Amendments in the drawings

Please replace Figs. 8-13 with Figs. 8-13 on the enclosed replacement drawing sheets.

Fig. 8

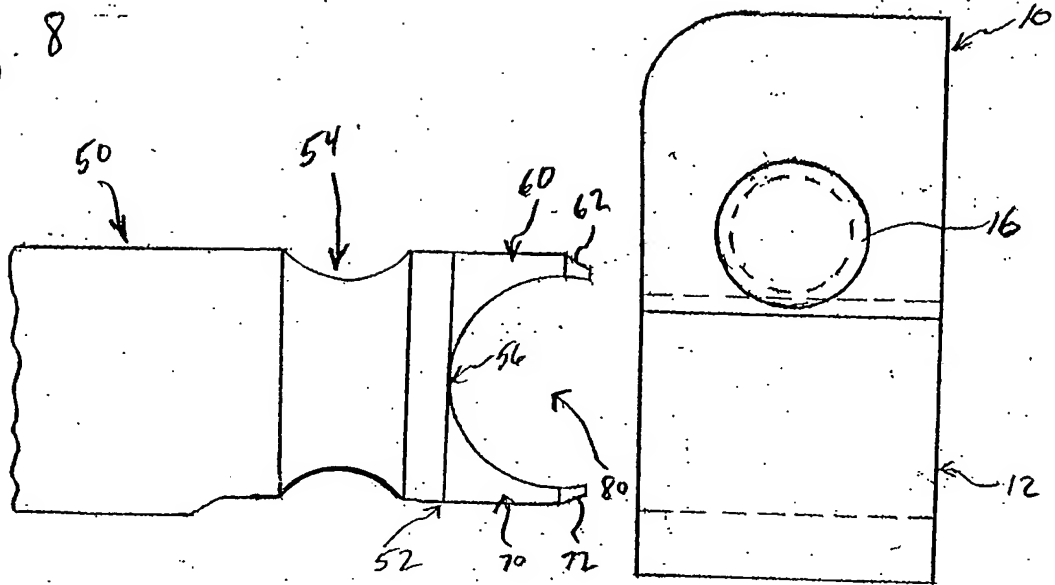
Figs. 8-13 have each been amended to show the bolt retaining recess 54 as an annular groove.
